Contract #: 04-0120F4Cty: SF/ALA Rte: 80 PM: 13.2/13.9File #: 69.25B**QUALITY ASSURANCE -- NON-CONFORMANCE REPORT****Location:** Changxing Island, Shanghai, PRC**Report No:** NCR-000384**Prime Contractor:** American Bridge/Fluor Enterprises, a JV**Date:** 14-Aug-2009**Submitting Contractor:** Zhenhua Port Machinery Company, Ltd (ZPMC), Changxing Island**NCR #:** ZPMC-0358**Type of problem:****Welding****Concrete****Other****Welding****Curing****Procedural****Bridge No:** 34-0006**Joint fit-up****Coating****Other****Component:** North Tower**Procedural****Procedural****Description:** North Tower, Lift 1, Diaphragm to Fit Lug weld**Reference Description:** Missed MT indication on North Tower, Lift 1, Skin E, 38m Diaphragm to Fit Lug weld**Description of Non-Conformance:**

**Subject:** NCR No. ZPMC-0358

**Reference Description:** Missed Indication (MT) / North Shaft Lift 1 / Fit Lug Weld

# Nonconformance Report

Draft of Welding Discontinuity:

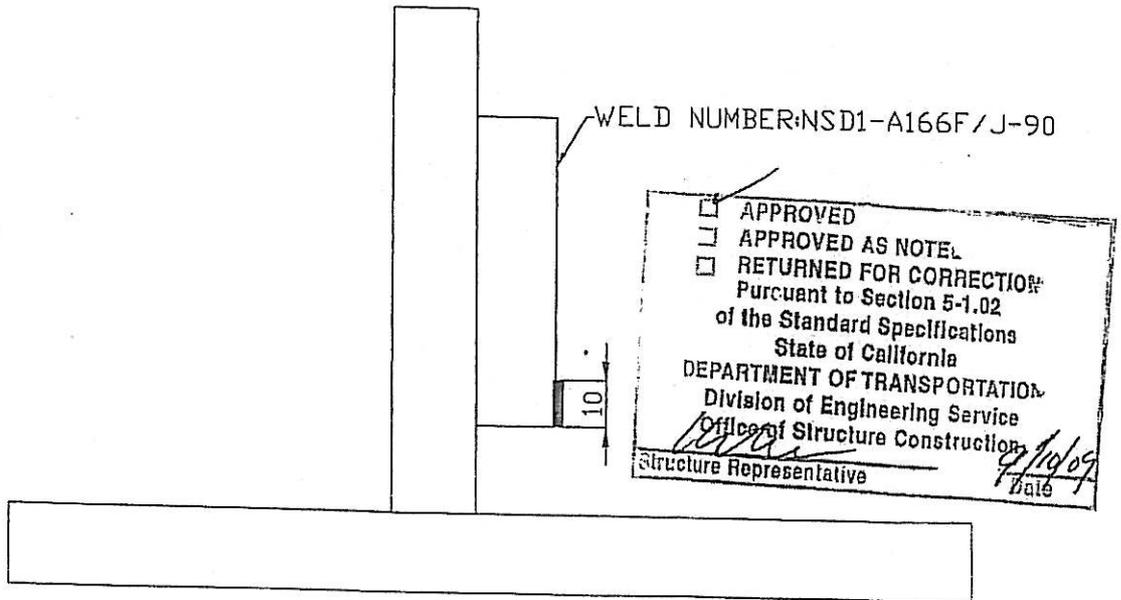
在对NSD1-A166F/J-90检测时, 发现1处线性缺陷。

One line indication was found by use of MT on NSD1-A166F/J-90.

1. 火焰加热时, 水汽没有完全的去掉或者这个区域预热不够;
1. Moisture wasn't completely removed during drying operation (preheating) or the area wasn't preheated sufficiently.

1. QC shall monitor and direct the welder and the grinder doing the repair operation.
2. Preheat before gouging; the temperature shall be at least 65°C.
3. Gouge the weld to remove identified defects.
4. Joint details shall refer to the approved WPS repair.
5. Grind the gouged areas to a smooth and shiny surface.
6. Verify with VT and MT to ensure no defects remain in the weld joint prior to welding.
7. QC shall monitor all welding passes being deposited.
8. QC shall ensure all slag has been removed prior the deposition of next pass.
9. Preheat and maintain interpass temperature control in accordance with the WPS.
10. Blend the weld repaired areas into the adjacent weld or base metal by grinding.
11. Perform VT, MT and UT NDT inspection to the repaired areas.
